Geostatistical Stratigraphy (5-Mile)

Clinton LF, Clinton IL

Str. Johnson EPA 7/12/2010

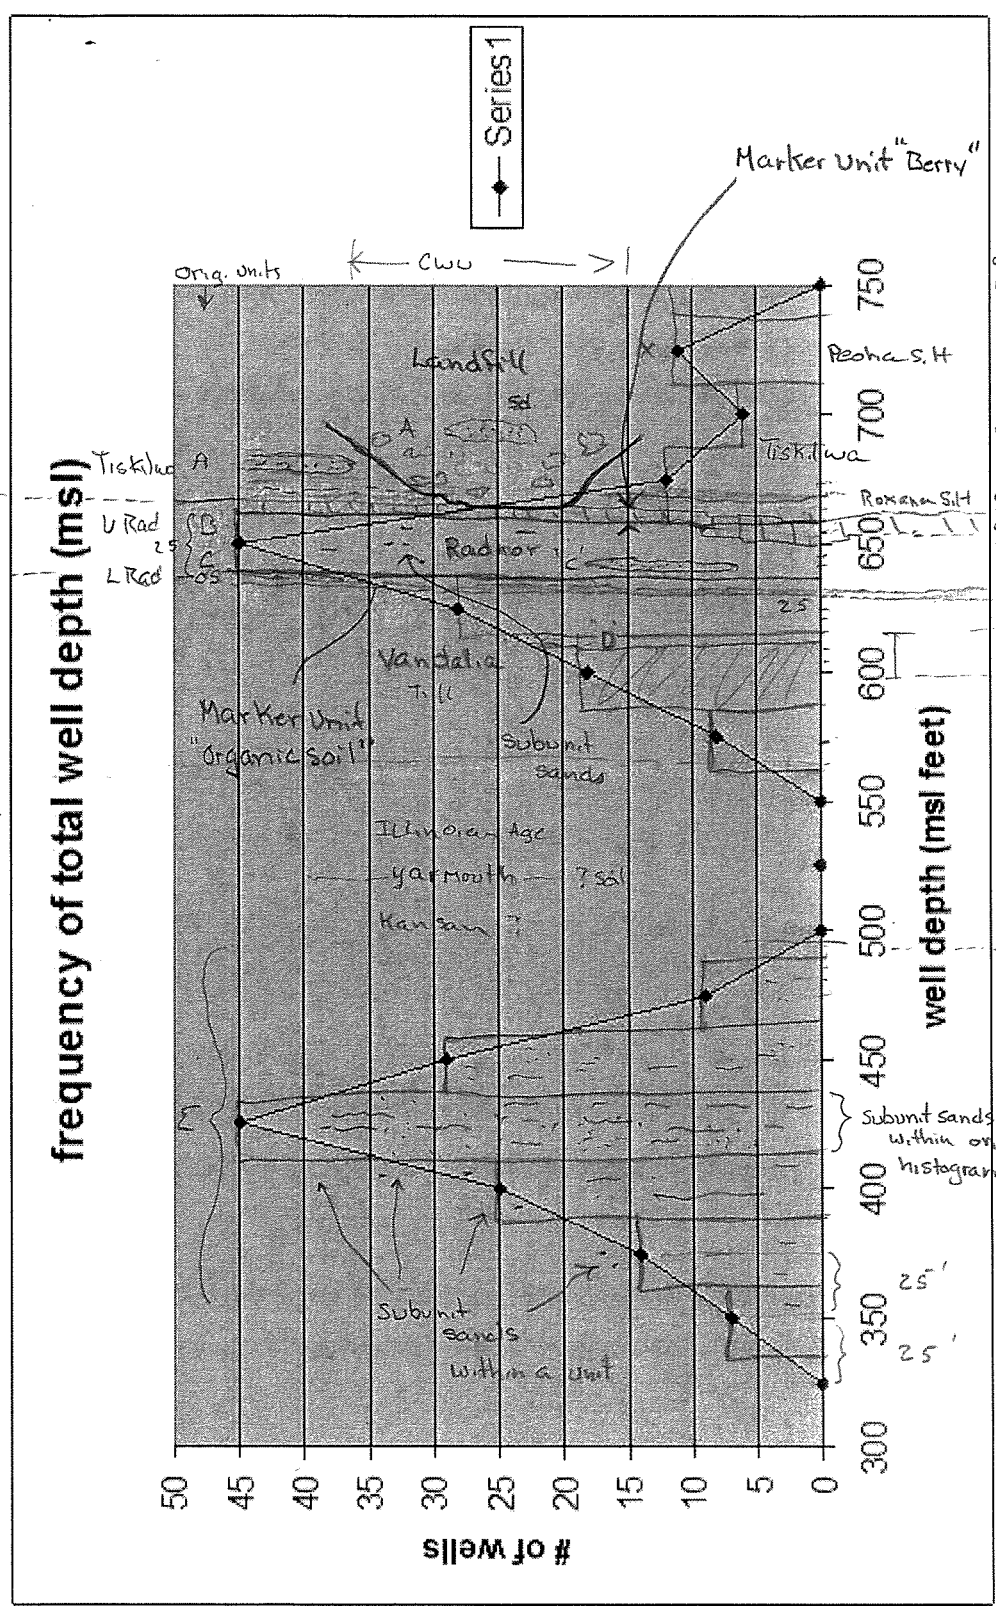
Name revised "units" ↓

For each unit 1-4, does fit... Show separation between "Subunit sands" or if not possible... Lump

Q: Is there really enough separation to make 2 blobs?

Test: ANOVA Variable 1 Tops.. Variable 2 bottoms Variable 3 Proximity
